- ADDENDUM -
- GUELPH CITY COUNCIL MEETING -
- JUNE 7, 2010 -

Memo To: Guelph City Council
From: Hugh Whiteley
Date: June 3 2010

Subject: 146 Downey Road Proposed Zoning Bylaw Amendment File ZCO906

Figure 1 Site Plan G with 16 units on valley slope

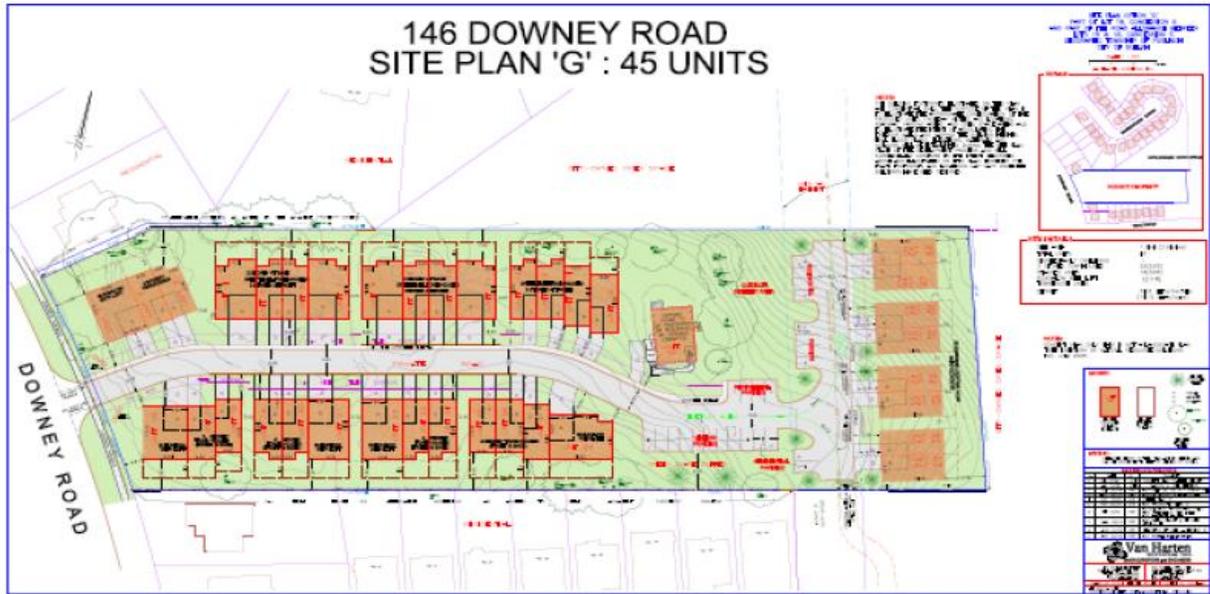
Figure 1 attached to this memo shows Site Plan G for 146 Downey with 16 housing units located on the eastern valley slope of the property. Early in the process of developing proposals for 146 Downey Road city staff were told by local residents and others that any buildings that intruded on the eastern valley slope of the property would create damaging visual impact on the Tributary A valley open space. They were also told that the views of this valley were an important natural asset for all visitors to the area, both local residents and less frequent visitors enjoying an extended walk along the trunk trail system that passes through the valley.

Any buildings on the 146 Downey eastern slope violate the basic rule of unobstructed valley slope that governs all the rest of the built form surrounding the Tributary A valley. Construction on the slope is a major incompatibility and thus in violation of the provision for compatibility in the Official Plan.

Figure 3 Sketch of possible configuration for 146 Downey with land swap; Option H.

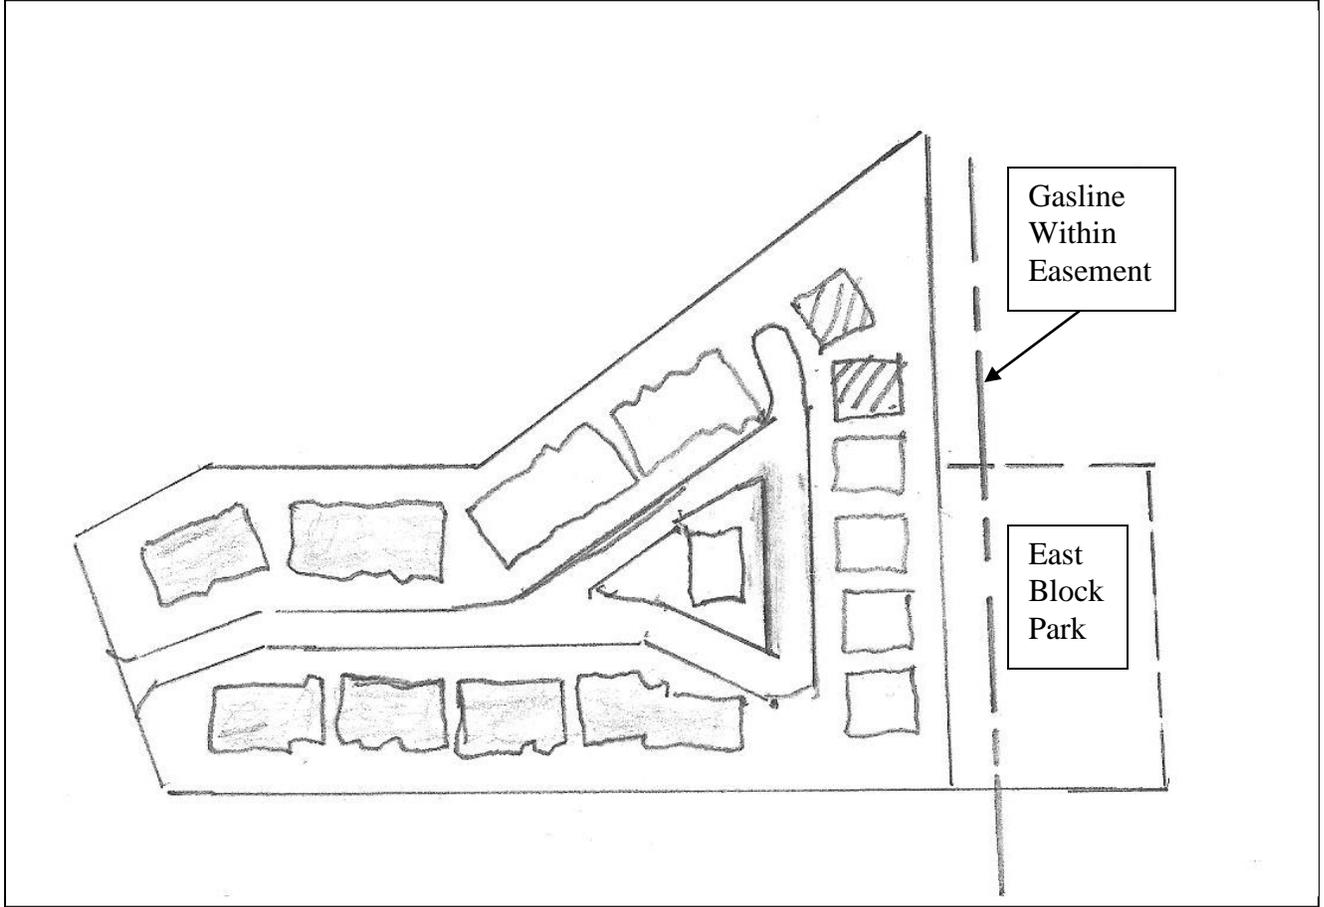
In Figure 3 I have provided a sketch that demonstrates that not only could all the 45 units be placed on the site after the land swap but two additional 4-unit buildings could be added to better realize the densities needed for sustainability. The one clear disadvantage of this option is that six properties along Hazelwood would have diminished views of the Tributary A valley from some vantage points on their property. Careful placement of the new buildings would mitigate this damage to some extent. In terms of proximity of building to these properties the separation would be similar to that of properties along Teal, a separation that has been judged acceptable by the neighbourhood for the Teal properties.

Note: In this configuration 6 buildings are located as per Option G, 6 buildings are relocated, and 2 additional buildings (8 additional units) are included for a total of 53 units.
